SFF-8639

Multifunction 6X Unshielded Connector

Rev 2.1.1 ~~March 22~~[April 2, 2024](#)~~April 2, 2024~~~~May 26, 2024~~

Revision 2.1.1

FIGURE 5-4 SECTION D-D, DEVICE FREE (PLUG) CONNECTOR

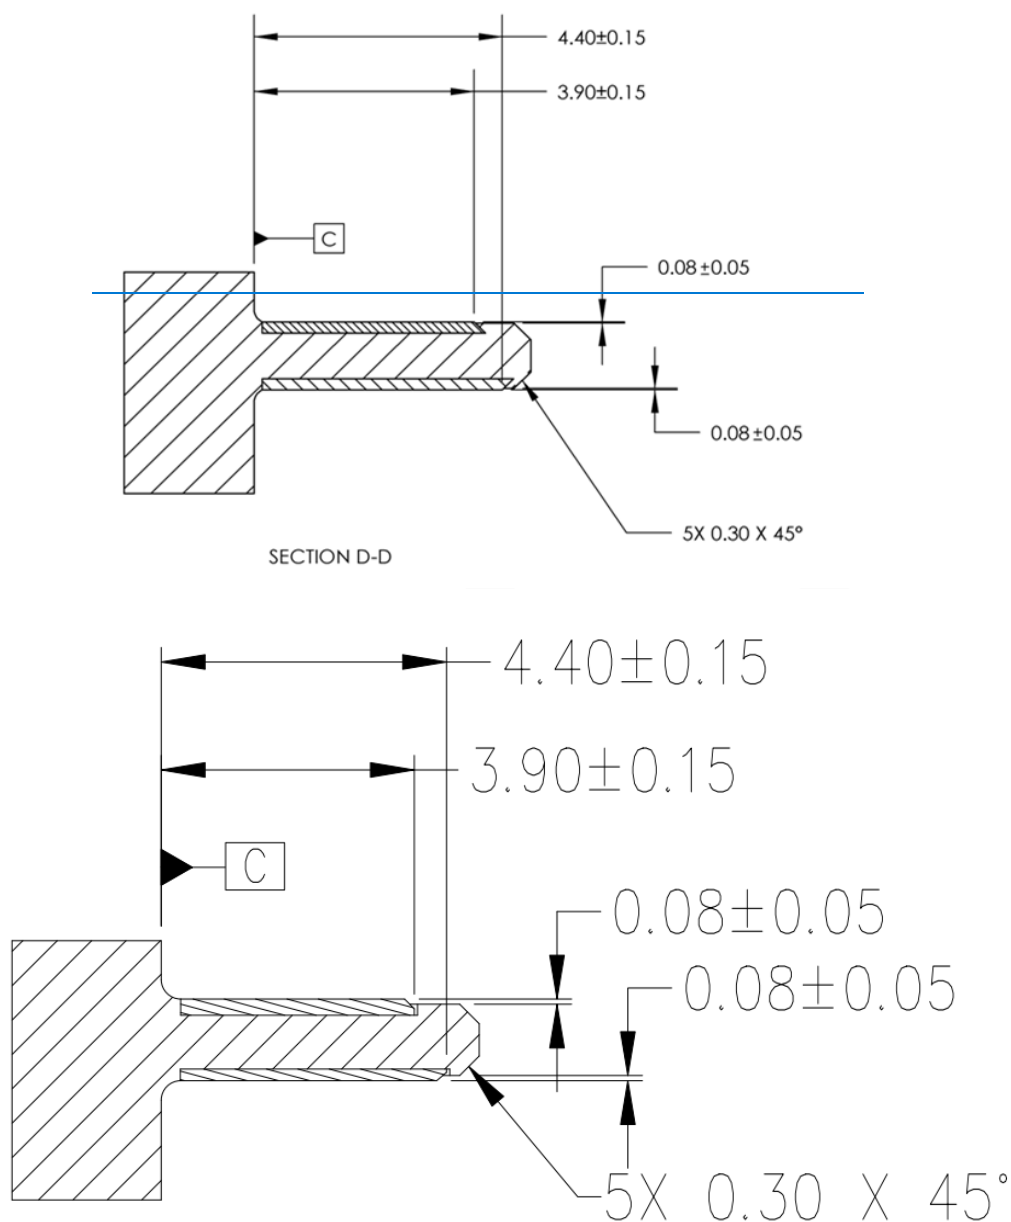
- Revised Figure 5-4~~Figure 4-4~~ to be consistent with SFF-8482 and manufactured parts.
- Changed to SFF template Rev 1.1.1
